Permit Number 0100547
 JUL

This is to certify that OAKHURST PROPERTIES LLC / PM Construction

has permission to Renovate existing building into 5-6 units for lease for retail or office space Vanilla spaces + 2 exterior ramps City of Portland

AT 332 FOREST AVE

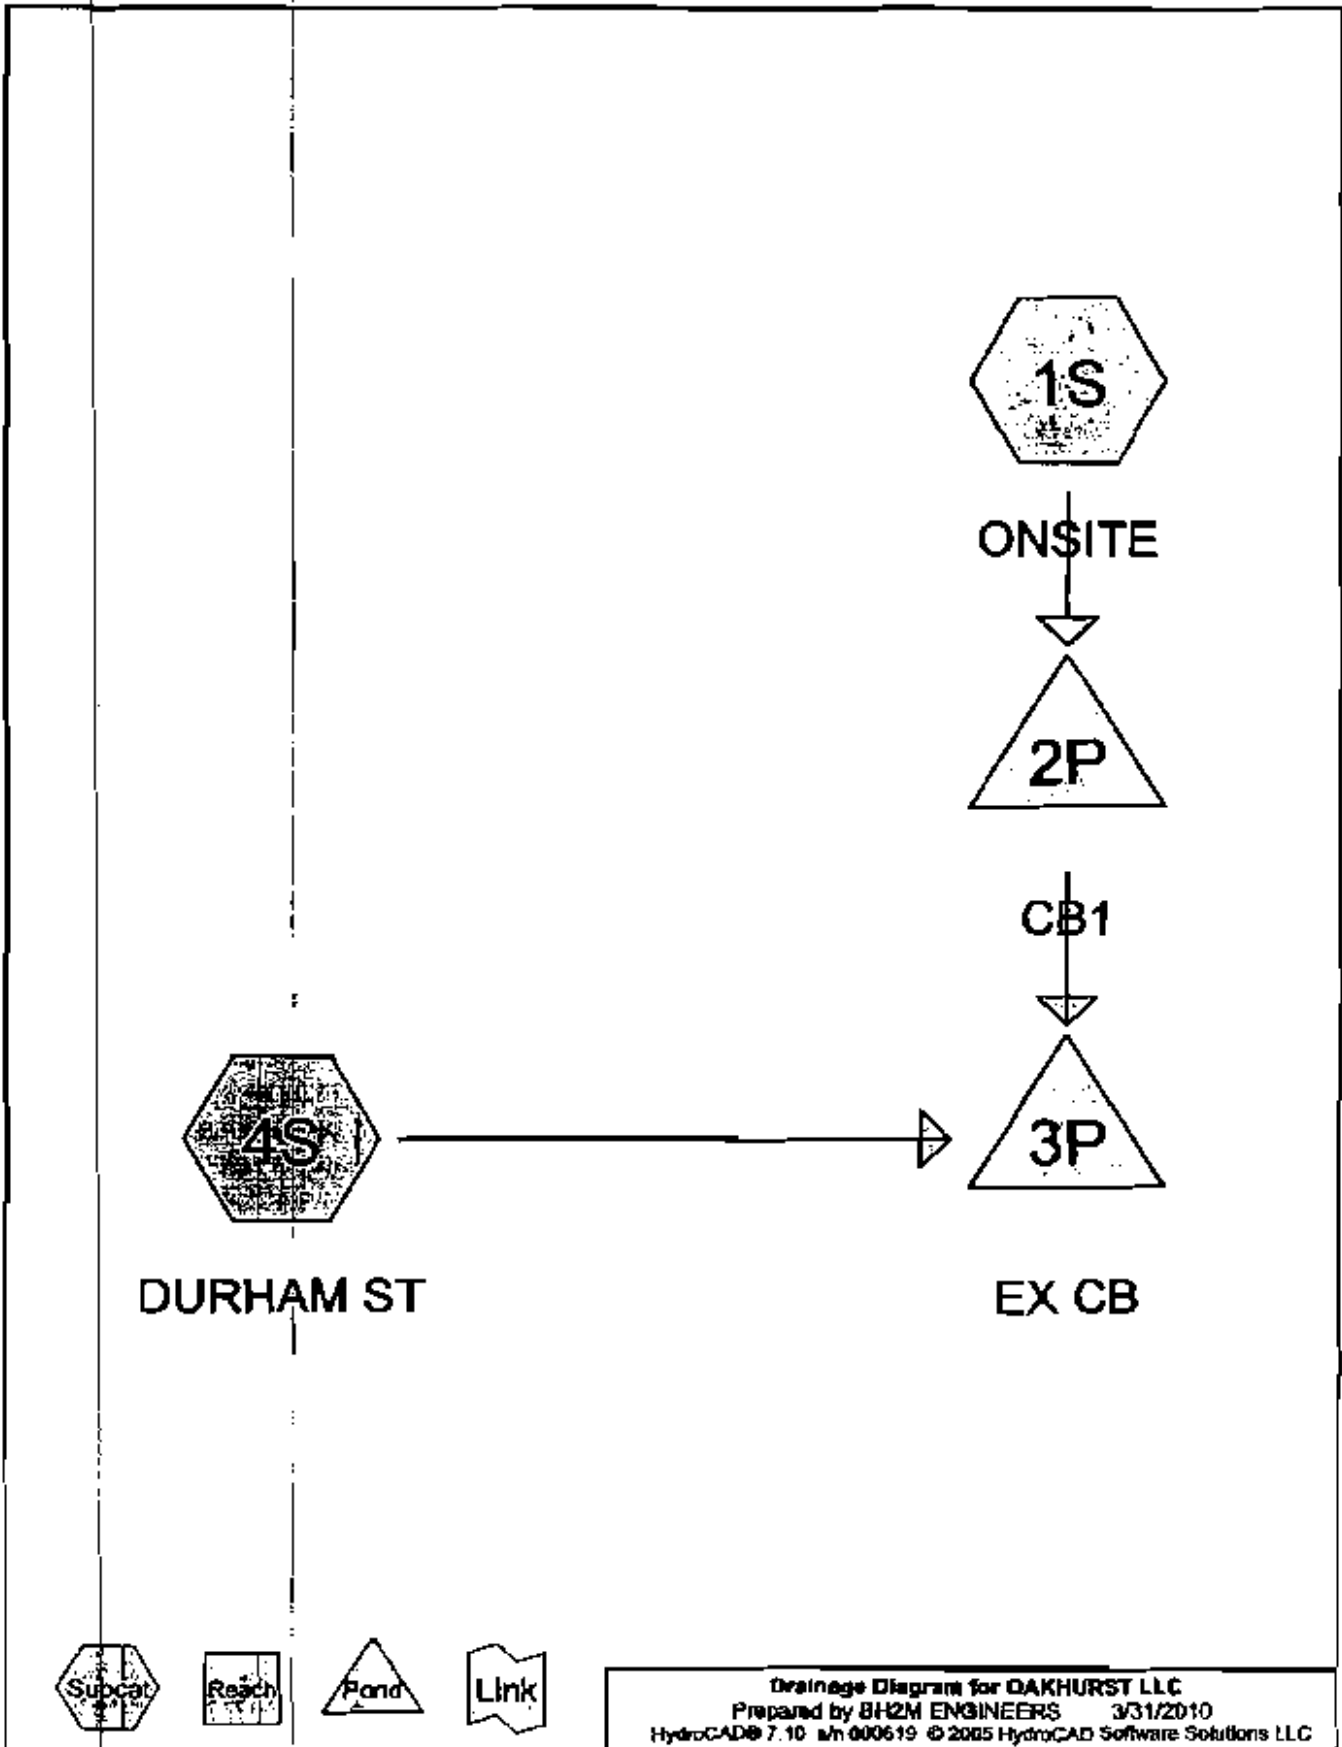
The review memo in Section E Consulting Engineers asks for evidence that the proposed and existing catchbasins will not flood due to the restriction of the existing 8" pipe. In response, we have attached the HydroCad Calculations Model with the two catchbasins and drainage areas:

CB1: Inv. = 18.72
Rim = 21.80
Peak = 19.29

CBG: Inv. = 18.50
Rim = 21.64
Peak = 19.50*

*Slight surcharge of 8" pipe.
